SERVICE BULLETIN

M-1234

2009 MODEL YEAR UPDATE BULLETIN

Figure 1. Bolt Types (typical)

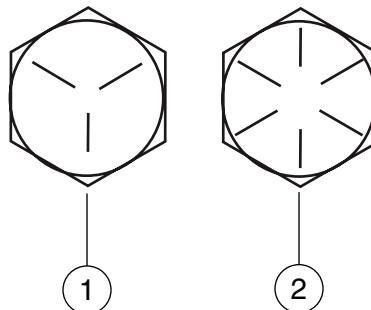
The lower fork bracket pinch bolts for Softail models changed from Grade 5 to Grade 8 as a running change during the 2009 model year. With this change, the torque spec also changed from 35-40 ft-lbs (47.5-54.2 Nm) to 50-60 ft-lbs (67.8-81.3 Nm). These same Grade 8 bolts will be the replacement bolts for this particular application.

See Figure 1. The Grade 5 bolt is identified by three lines on the bolt head and the Grade 8 bolt is identified by six lines on the bolt head.

- Always check bolt head markings before applying torque.
- Touring models (1995-2009) come equipped with the Grade 8 pinch bolts and can be torqued to the Grade 8 torque value listed above.
- FLHTCUTG Tri-Glide is also equipped with Grade 8 pinch bolts, however the torque value on this model exclusively, is 70-75 ft-lbs (94.9-101.6 Nm).
